# Access Compliance Report

## Public Rights-of-Way

### (Curb Ramps)

Intersection ID: 15988	Main Street: SOUTH_BV	Cross Street: HOLLIS_RD	Location: NE
ADA ID: D656B168C3B0	Ramp Type: PerpDiag	Initial Pass/Fail: Fail	Overall Compliance: No
Severity Score: 21.25			
Codes/Mitigation Info/Possible Solution		Field Measurements/Component Compliance

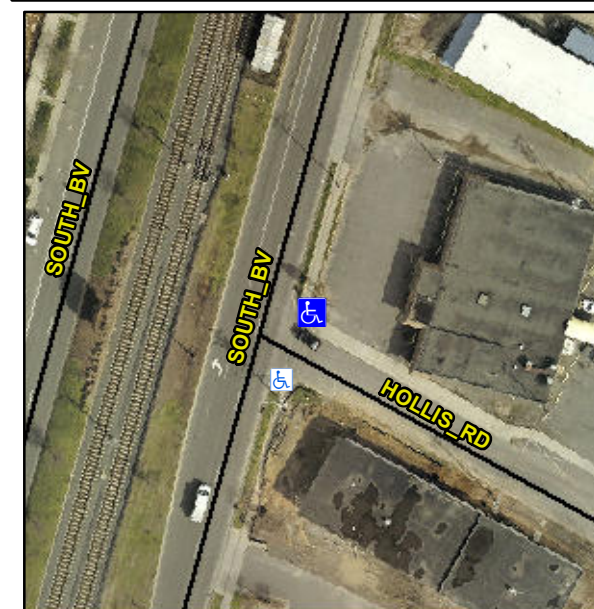
**Not Found, R304.5.1, R304.2.2**

Compliance	Description	Data	Compliance	Description	Data
N/A	Ramp Length (in)	72.0	No	Ramp Slope (%)	8.5
No	Ramp Width (in)	47.0	Yes	Ramp XSlope (%)	0.7
N/A	Flare Type LT	N/A	N/A	Flare Type RT	N/A
N/A	Flare Slope LT (%)	N/A	N/A	Flare Slope RT (%)	N/A
N/A	Flare Traversable LT?	N/A	N/A	Flare Traversable RT?	N/A
N/A	Landing Length (in)	N/A	N/A	DWS Provided?	N/A
N/A	Landing Width (in)	N/A	N/A	DWS Contrast?	N/A
N/A	Landing Slope (%)	N/A	N/A	DWS Length (in)	N/A
N/A	Landing X Slope (%)	N/A	N/A	DWS Full Width?	N/A
N/A	Landing Curb? (Y/N)	N/A	N/A	DWS Offset (in)	N/A
N/A	Shared Landing?	N/A			
N/A	Gutter Ponding?	N/A	N/A	Gutter Slope (%)	N/A
N/A	Gutter Lip Ht (in)	N/A	N/A	Gutter X Slope (%)	N/A
N/A	Painted X Walk1?	No	N/A	Painted X Walk2?	No
	X Walk 1 Direction	To NW		X Walk 2 Direction	To SW
N/A	X Walk 1 Width (in)	N/A	N/A	X Walk 2 Width (in)	N/A
	X Walk 1 Slope (%)	3.9		X Walk 2 Slope (%)	0.3
	X Walk 1 X Slope (%)	6.2		X Walk 2 X Slope (%)	0.8

**Remove & Replace Curb Ramp With Two New Directional Ramps or Equivalent.**
